DEVELOPMENT APPLICATION ASSESSMENT REPORT

Application Number:	DA2024/1244
----------------------------	-------------

Responsible Officer:	Dean Pattalis
Land to be developed (Address):	Lot 26 DP 7435, 23 Tasman Street DEE WHY NSW 2099
Proposed Development:	Alterations and additions a dwelling house
Zoning:	Warringah LEP2011 - Land zoned R2 Low Density Residential
Development Permissible:	Yes
Existing Use Rights:	No
Consent Authority:	Northern Beaches Council
Land and Environment Court Action:	No
Applicant:	William Fleming

Figure 1: Northern envelope non-compliance

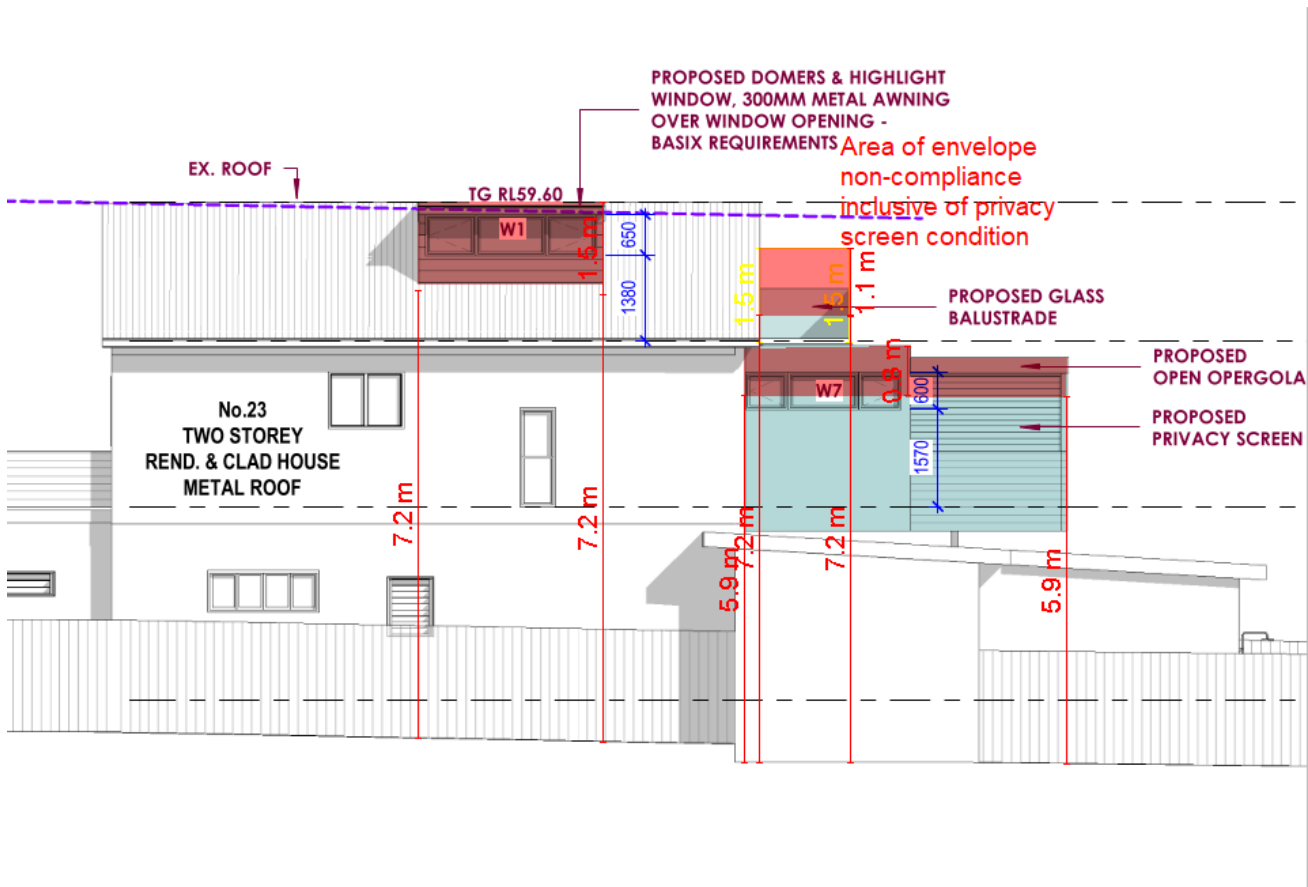
The proposed development encroaches the building envelope on the western elevation.

As per Figure 1, the non-compliance relates to an area of the proposed first floor extension and attic dormer. Furthermore, as discussed elsewhere in this report, a new privacy screen is required via condition of consent at the western elevation of the proposed attic balcony. The outline of this privacy screen has been included in the area of non-compliance.

Despite the above, the proposed areas of non-compliance are considered to be minor and of minimal vertical or horizontal distance. The proposed additions follow the existing compliant western side setbacks of the existing dwelling which results in the proposed numerical non-compliances. The site is also burdened by a narrow allotment width which limits the ability to wholly comply with the control. The proposed areas of non-compliance are not considered to result in any unreasonable bulk and scale or amenity impacts to surrounding properties. The proposal is numerically compliant with all remaining principal development standards and built form controls including building height and the eastern side envelope.
